Executive Director's Recommendation

Commission Meeting: July 13, 2017

PROJECT National World War I Memorial Pershing Park Washington, DC	NCPC FILE NUMBER 7682
	NCPC MAP FILE NUMBER 1.23(73.10)44510
SUBMITTED BY United States Department of the Interior National Park Service	APPLICANT'S REQUEST Approval of comments on concept design
REVIEW AUTHORITY Per 40 U.S.C § 8905 and Public Law 113-291	PROPOSED ACTION Approve comments as requested
	ACTION ITEM TYPE Staff Presentation

June 2017 Restored Pool Concept

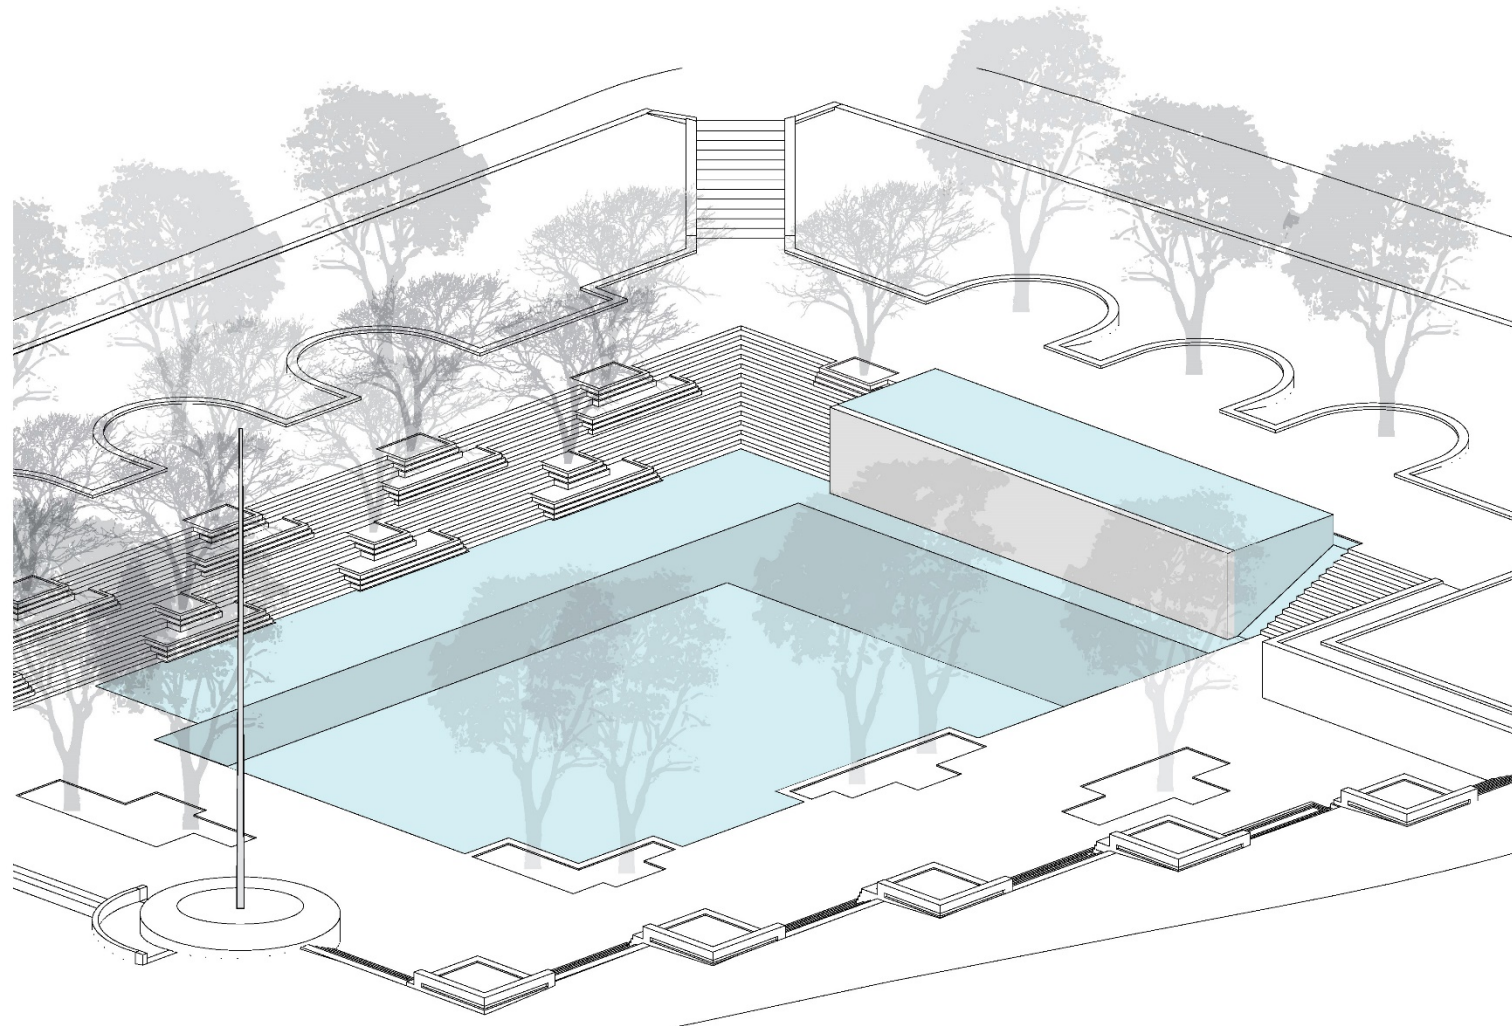
Requests the applicant provide additional details regarding the proposed pool modifications, including the design of the proposed pedestrian path, to demonstrate the impacts of any changes on the character of the pool and the visitor experience.

The revised design retains the footprint of the pool and inserts a circulation path to allow pedestrians to view the commemorative wall up-close. Based upon the submission materials, the water depth, pool materials and pedestrian path treatments are unclear. The applicant should further develop the proposal, while also evaluating pedestrian circulation and safety, including fall protection. As such, staff recommends the **Commission request the applicant provide additional details regarding the proposed pool modifications, including the design of the proposed pedestrian path, to demonstrate the impacts of any changes on the character of the pool and the visitor experience.**

June 2017 Restored Pool Concept Modifications to Existing Park

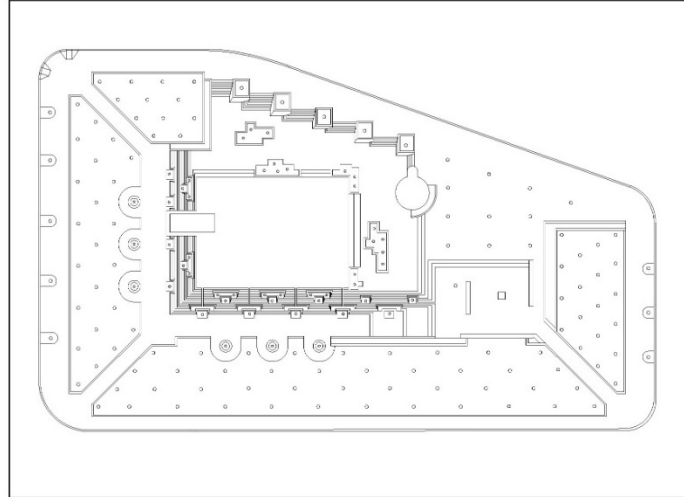
Requests the size of the commemorative wall be reduced to improve views across the park, and consider opportunities for better integrating the wall into the existing terracing and steps.

The proposed size and scale of the wall has several implications. As noted above, the length and height create a visual and physical barrier to the western portion of the site, not present in the original park design. The free flow of space between activity areas is one of the character-defining features of the existing park, and it would be altered under the proposed design. Staff notes that another important component of the central plaza is the terracing. The applicant should consider whether the proposed wall and terracing can be better integrated, and therefore avoid appearing as a barrier. Modifications to the design may also allow the steps and seating areas to expand, where appropriate. Therefore, staff recommends the **Commission request the size of the commemorative wall be reduced to improve views across the park, and consider opportunities for better integrating the wall into the existing terracing and steps.**
